ADEQUACY OF STATION ELECTRIC DISTRIBUTION SYSTEM
VOLTAGES, BRUNSWICK STEAM ELECTRIC PLANT, UNIT
NOS. 1 AND 2

Informal Report

Prepared for the
U.S. NUCLEAR REGULATORY COMMISSION
Under DOE Contract NO. DE-AC07-76ID01570
FIN No. A6429

1. Brunswick Nuclear Power Station electrical single-line diagram	5
---	---

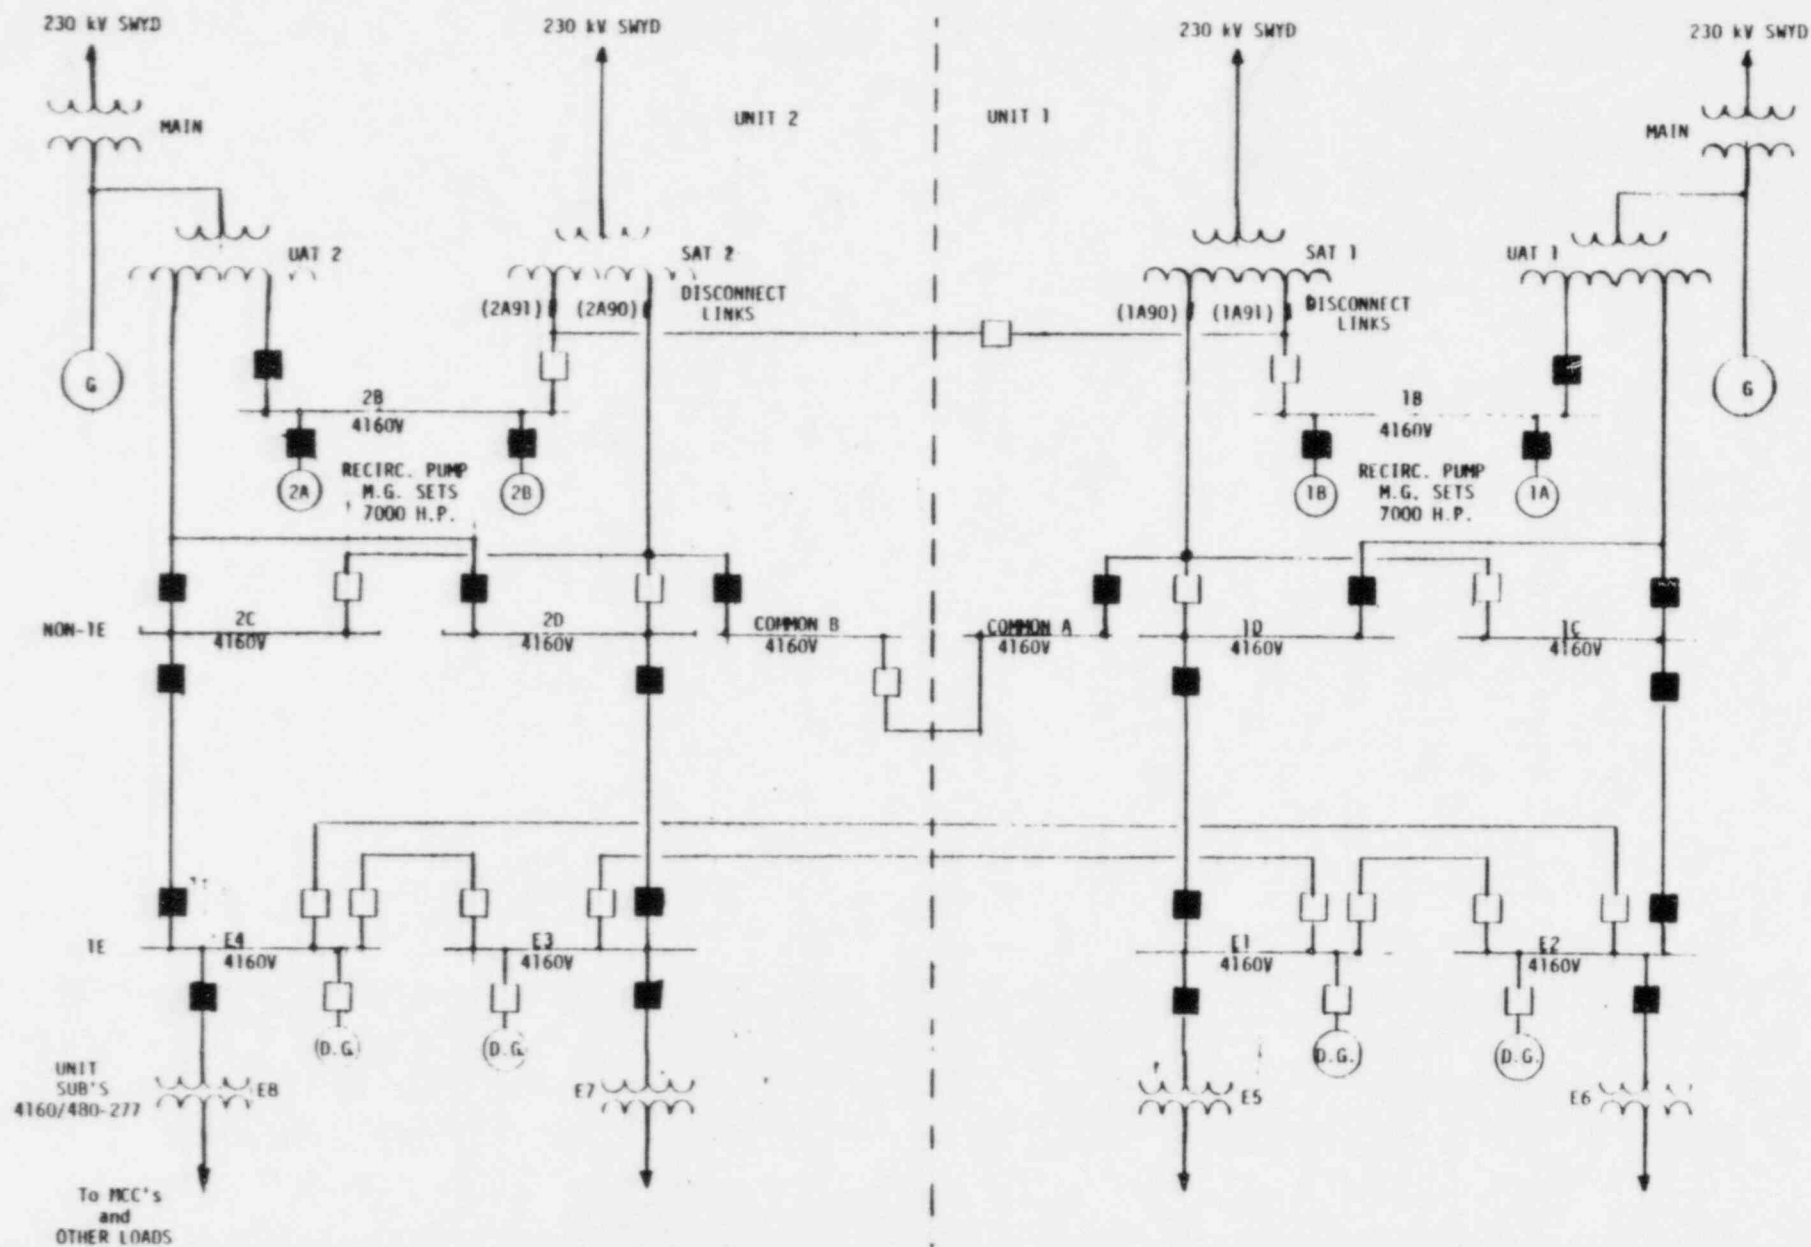
A single-line diagram of the ac electric distribution system at Brunswick is shown in Figure 1. The following system description pertains to Unit 2; Unit 1 is similar.

Regarding unit and bus tie breakers, the licensee states that with the exception of non-Class 1E 4160 V buses common A and common B, electrical interlocks prevent the interconnection of Unit 1 and Unit 2 buses. Class 1E 4160 V tie breakers (between buses E4 and E3) have been disconnected and racked out (Reference 5). The tie breaker between non-Class 1E buses 2B and 1B can only be closed if one of the incoming feeder breakers from a startup auxiliary transformer is open and one of the disconnect links (2A91, Unit 2 or 1A91, Unit 1) is removed. The tie breaker between non-Class 1E 4160 V buses common A and Common B can only be closed if the incoming feeder breaker to one of the buses is open. The Class 1E tie breaker between Class 1E 4160 V buses E4 and E2 and between E3

and E1 are normally open and an accident signal will trip them to insure they are open in an accident situation. The tie breakers between Class 1E 480 V buses E7 and E8 (not shown) are normally open.
